SUBJECT: GRAND GULF NUCLEAR STATION, UNIT 1 - STAFF ASSESSMENT OF  
FLOODING FOCUSED EVALUATION (CAC NO. MF9897; EPID  
L-2017-JLD-0015)

STAFF ASSESSMENT BY THE OFFICE OF NUCLEAR REACTOR REGULATION

GRAND GULF NUCLEAR STATION, UNIT 1

**Attachment – Staff Assessment of Grand Gulf Nuclear Station, Unit 1  
Revised Local Intense Precipitation Model**

Figure A1-1. Site Map with FLO-2D Model Layout

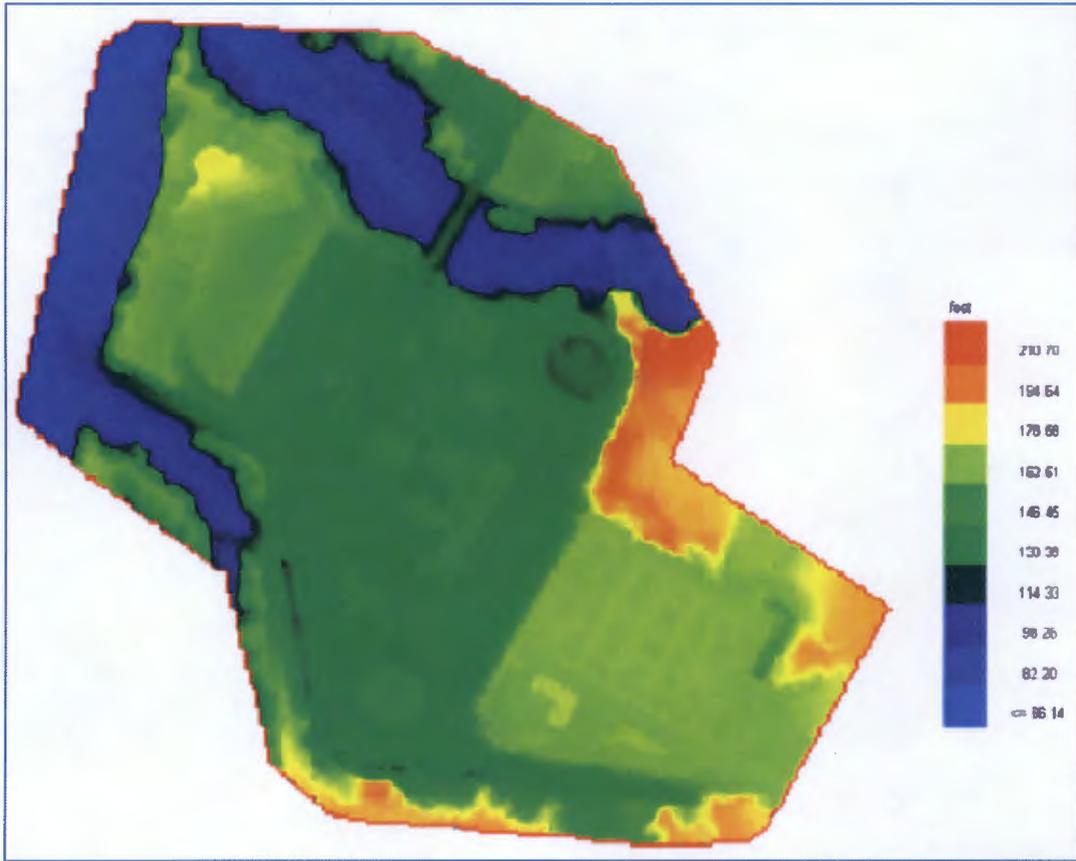
Figures A1-1 and A1-2 show the model grid and inundation flood map results using the revised FLO-2D model. The licensee verified the water budget calculation for the simulations as discussed in their calculation. The licensee reported in its FE report that the total model inflow (rainfall) is equal to the sum of outflow and storage components, indicating nearly zero water budget errors. The staff confirmed the water budget equality between the simulated inflow and outflow components, and also confirmed there were no numerical stability issues. Therefore, the staff determined that the revised FLO-2D model and simulation results are acceptable for use in the FE.

Figure A1-4 Example stage hydrographs for Door 2M111 (top) and Door OCT5 (below)

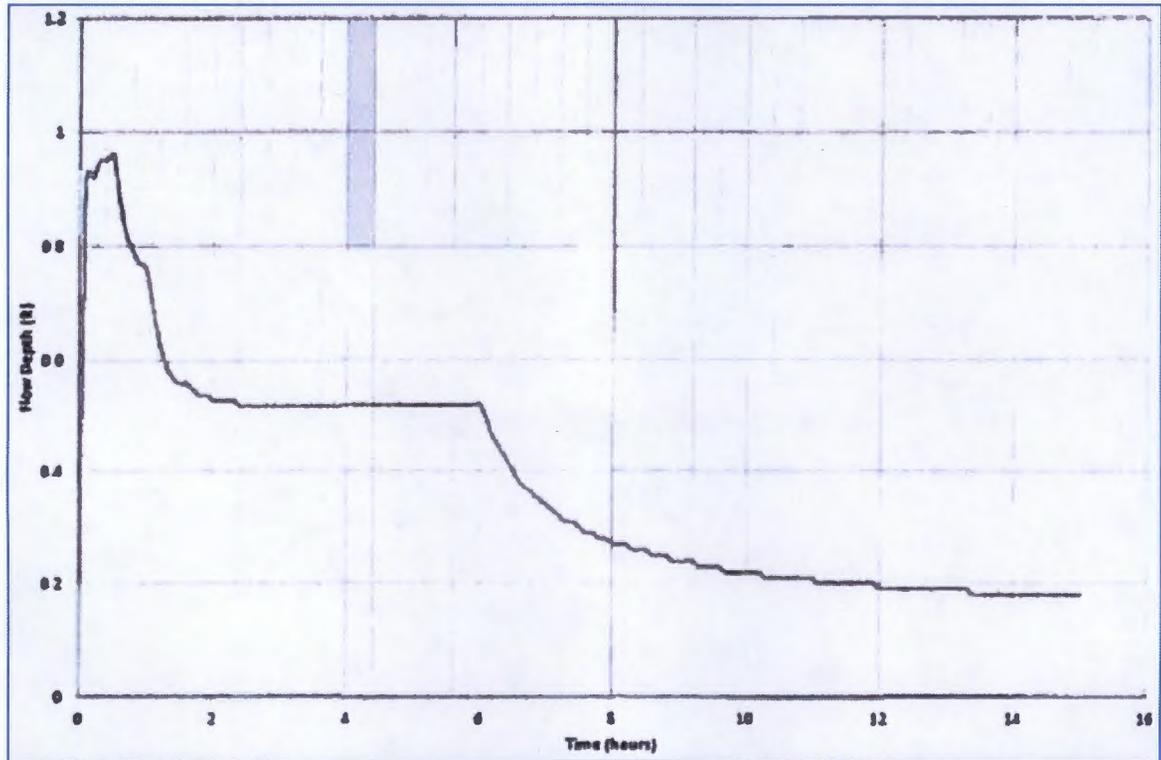
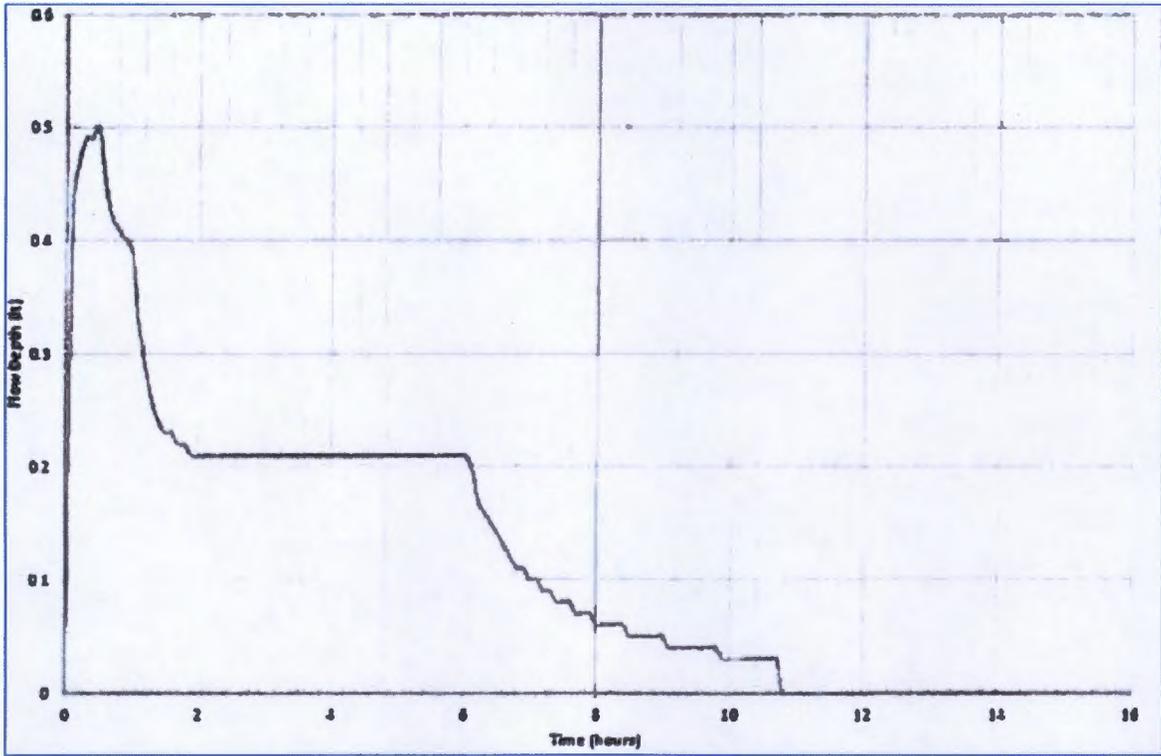
- The licensee noticed zero inundation depth after approximately 11 hours of simulation time at the Door 2M110 (Grid Cell No. 19579 with elevation 133.09 ft. MSL) (Figure A1-4, top). The licensee found that this grid cell has considerably higher elevation compared to nearby grid cells. Therefore, ponding for a long time with a relatively constant flow depth is not expected, justifying the full drain (flow depth down to zero) shown in the stage hydrograph.

- At the Door 0CT5 (Grid Cell No. 25481 with elevation 132.67 ft. MSL) location, the licensee noted approximately 0.2 ft. inundation depth at the tail of the hydrograph (see Figure A1-4, bottom). The licensee stated in its FE that this grid cell and other close-by cells are flat and have relatively lower elevations compared to the outer surrounding cells, justifying the prolonged inundation pattern at this location. They found the same inundation pattern at door locations 1D312, 1D310, and 2M111.

Therefore, the licensee concluded that the long-tails in the hydrographs are realistic and consistent with the topography and ground elevations surrounding these doors. Based on an independent review of the hydrographs generated from the revised FLO-2D output files, the staff determined the hydrographs simulated by the revised FLO-2D are reasonable. Table A1-1 summarizes the revised LIP flood elevations as well as flood depths at key monitoring locations.
